*Owner:* Resort Municipality of Whistler  
(NAME OF OWNER)

*Contract:* Village Gate Manhole Replacement Project  
(TITLE OF CONTRACT)

*Reference No.* E32002-2020  
(OWNER'S CONTRACT REFERENCE NO.)

# Addendum #1, Attachment #5 (Page 1 of 1)

## PLAN & PROFILE MANHOLE REPLACEMENT & BYPASS/HOT-TAP DETAILS

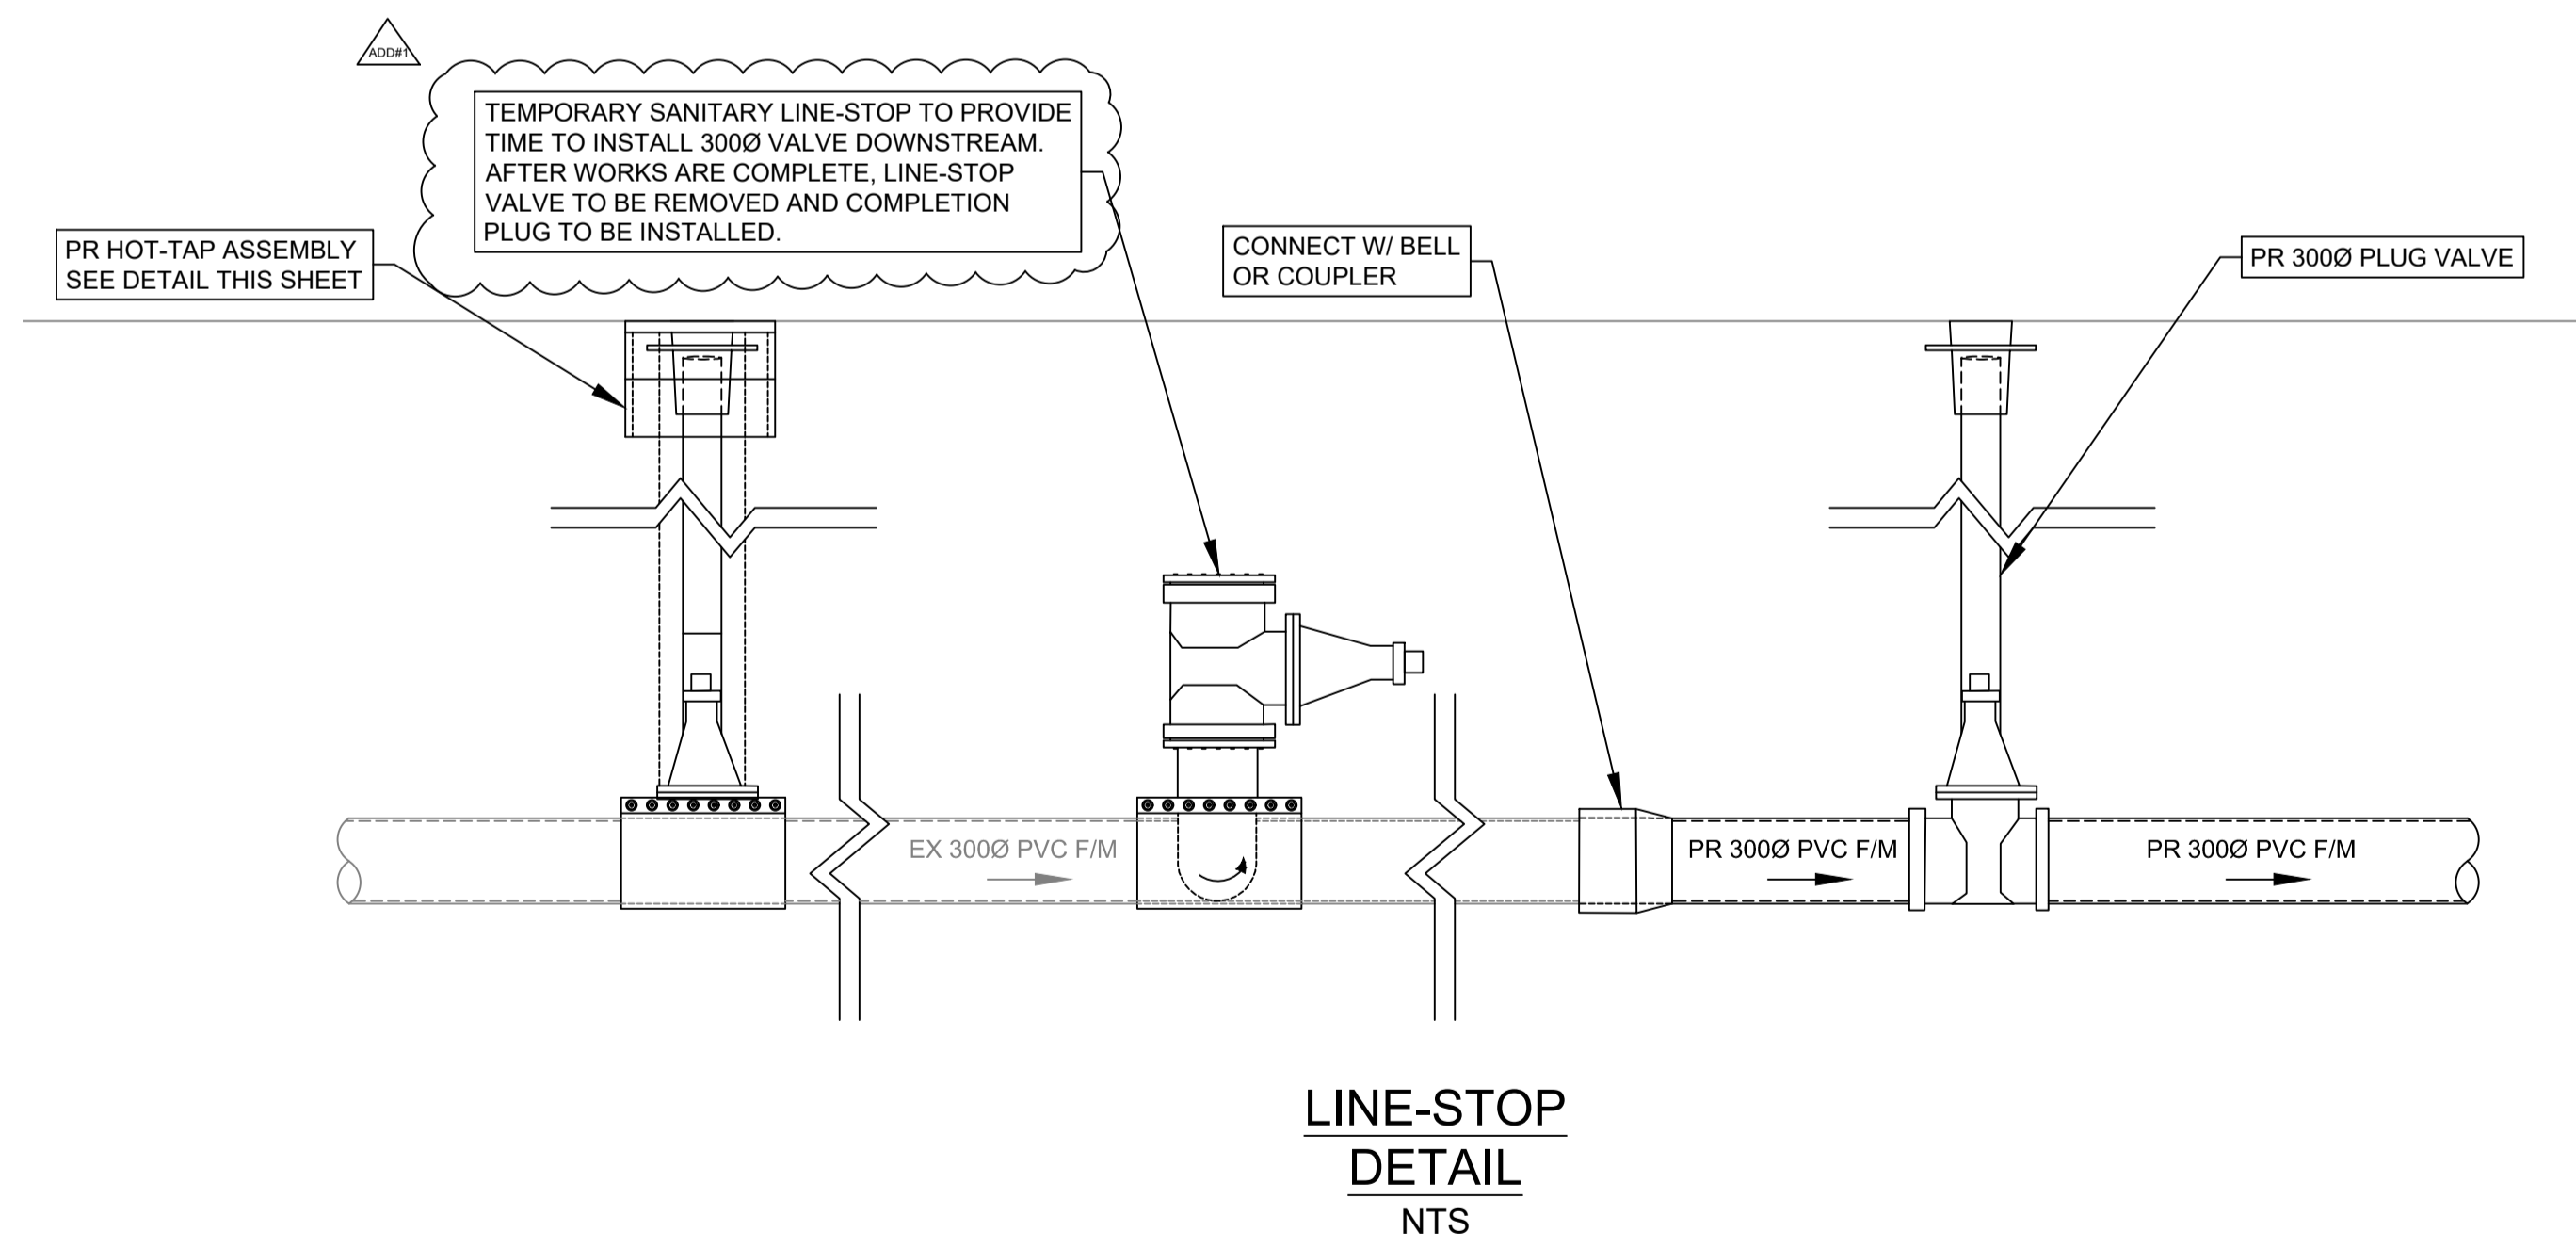
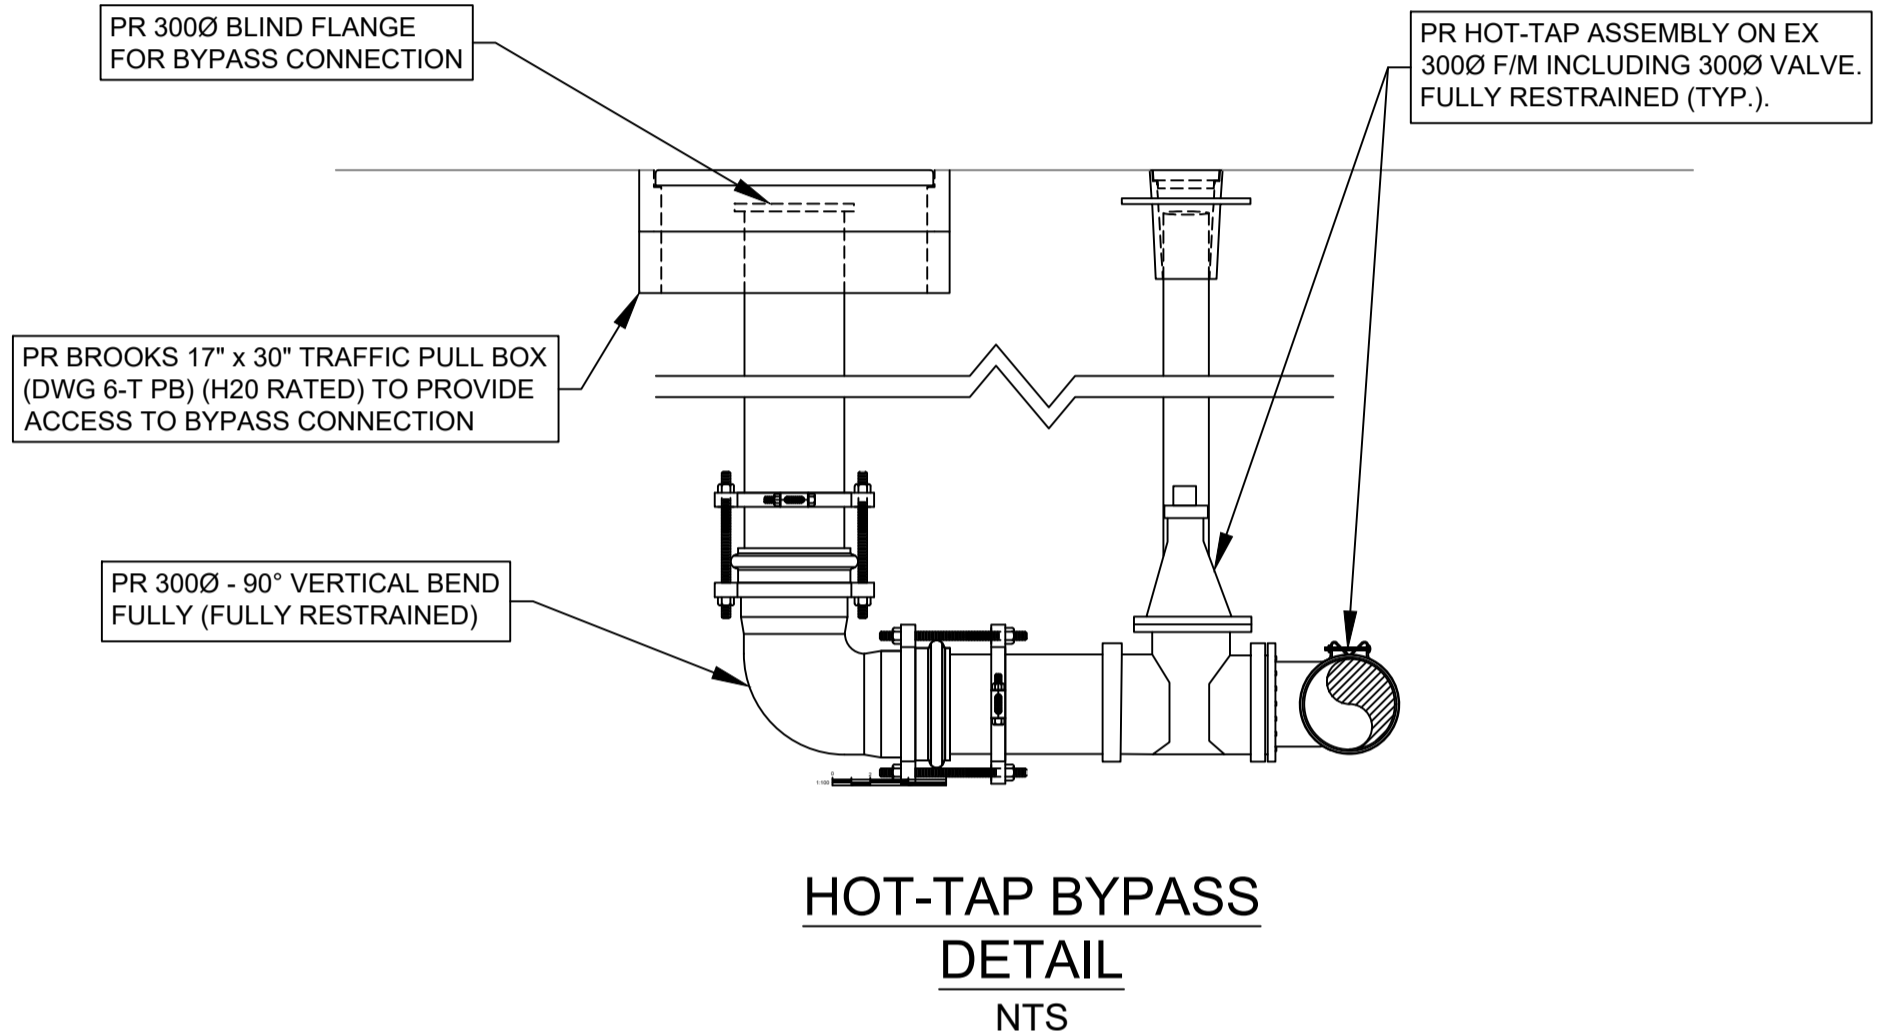
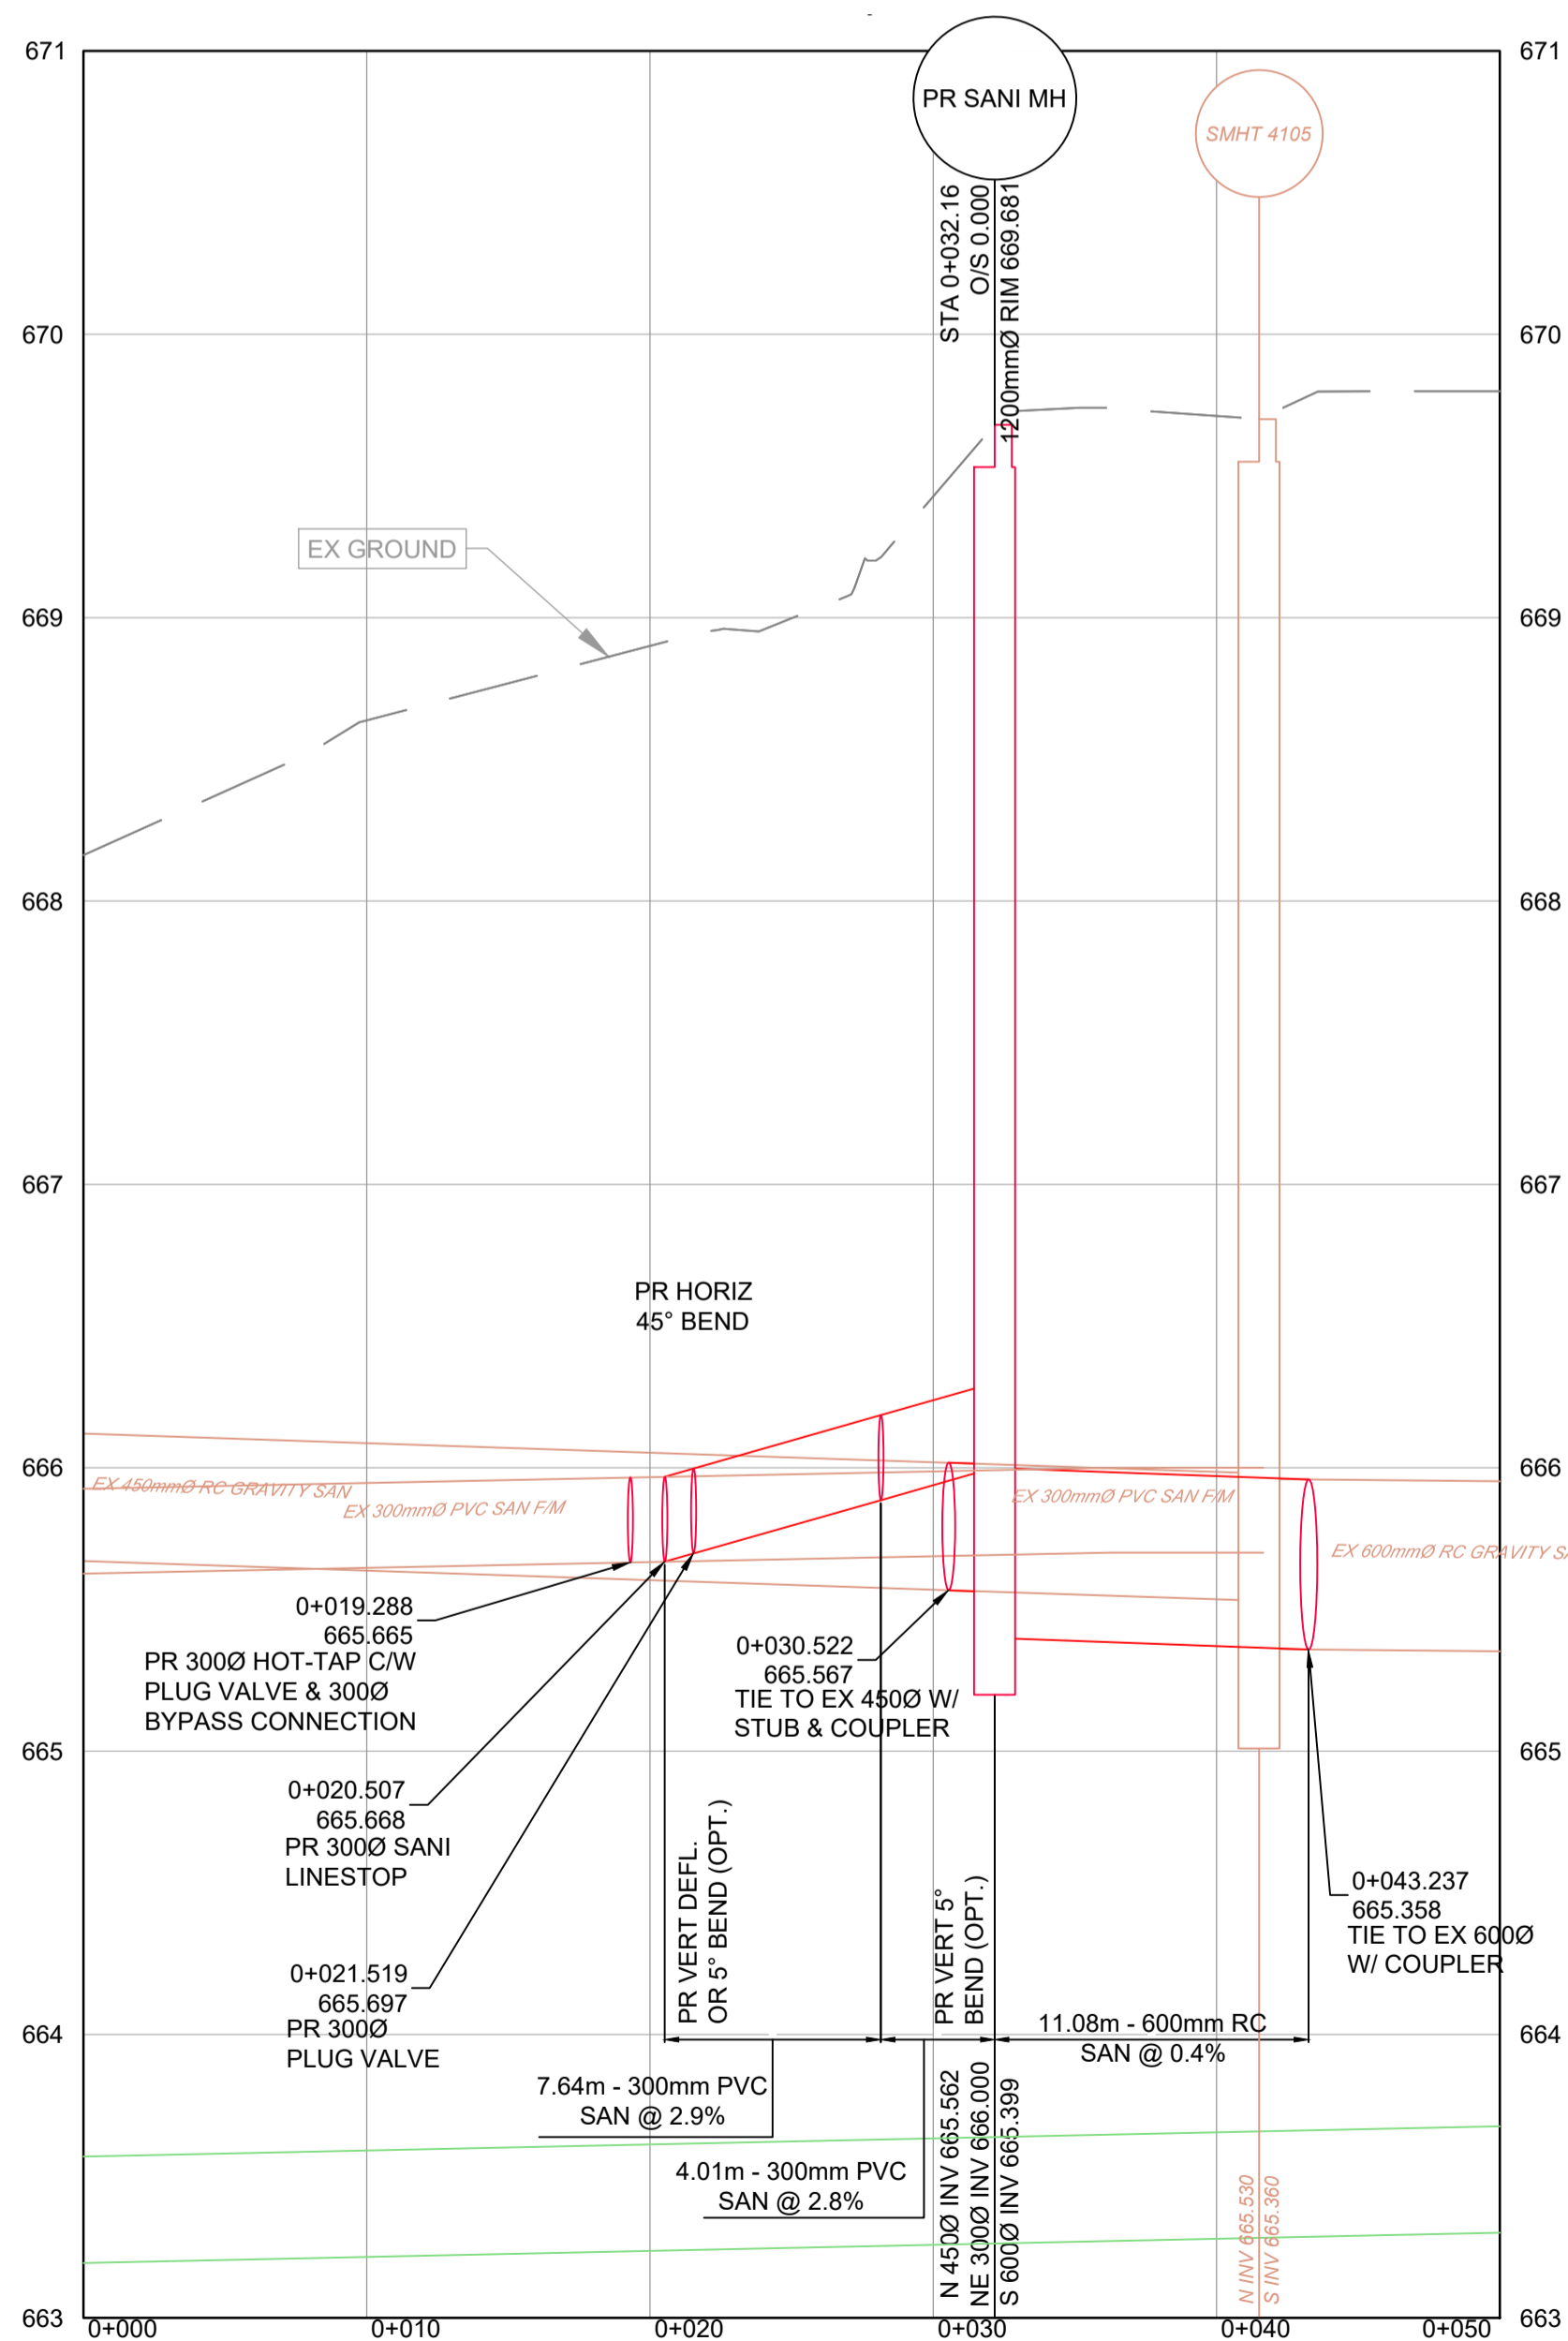
Drawing No. 32266-3

**Q2: Is a Mueller Gate Valve suitable for the lateral hot tap? Apparently a Plug Valve cannot be used for a hot tap.**

**Q3: Is the Line Stop Valve to remain or is the valve to be removed and capped with a plug stop and blind flange once the inline Plug Valve is installed?**

Addendum #1, Attachment #5

*A2: See Addendum #1, Attachment #5 for clarification.*

*A3: The line stop will not remain. See Addendum #1, Attachment #5 for clarification.*
